1MCo3 Main Works - Contract Lot S1

Schedule 17 Plans and Specifications - Written Statement - Amendment to Berm Wall Pack 1 (South of Mornington Street Bridge to northern extent of Euston Cavern Headhouse) - Park Village East Wall S1

Document no.: 1MC03-SCJ_SDH-IN-STA-SS01_SL03-000005

**Schedule 17 Plans and Specifications Written
Statement for Information**

Figure 3 Comparison of materiality between approved and amendment schemes.

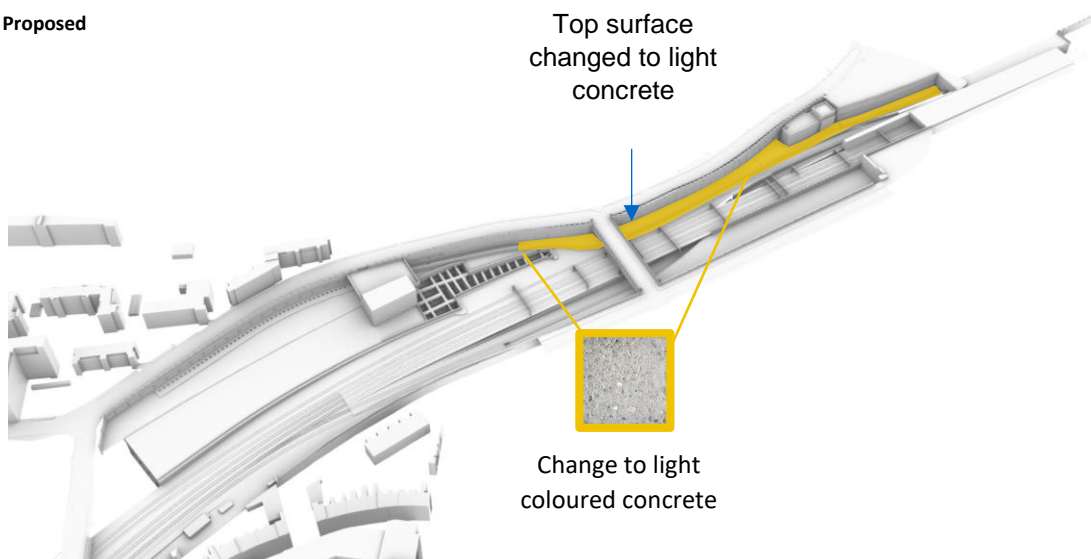
- 3.4.1 The Park Village East Berm & Upstand was granted approval, under Schedule 17, on 17 March 2021 (LPA ref: 2021/0126/HS2) by the London Borough of Camden.
- 3.4.2 The current submission seeks to amend the central section of this approved scheme (Cavern Headhouse to Mornington Street bridge). Amendments for the north and south sections of the approved scheme will be dealt with in two subsequent Schedule 17 consent applications.
- 3.4.3 The key amendments in the current submission (**Figures 3 - 5**) include:
- Replacement of parapet wall with lower pre-cast L-shaped reinforced concrete wall panels;

- Removal of the significant upstand element, apart from to the rear of the Euston Cavern Shaft where it will be concealed from view;
- Change in colour of berm support structure from 12% pigmented to non-pigmented concrete.

Figure 4 Comparison between approved and amendment schemes showing removal of upstand element

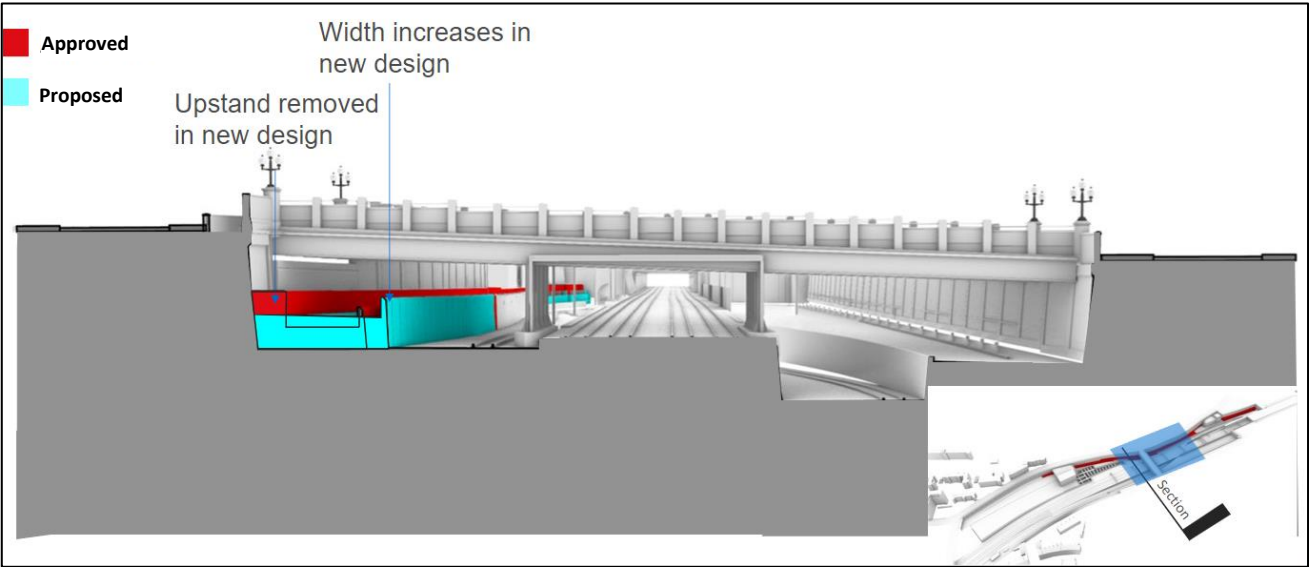
- 4.2.4 In terms of minor changes to design and external appearance, in comparison to the approved scheme, the proposal omits the upstand and, at some points along the Berm's length, reduces the height of the berm wall.
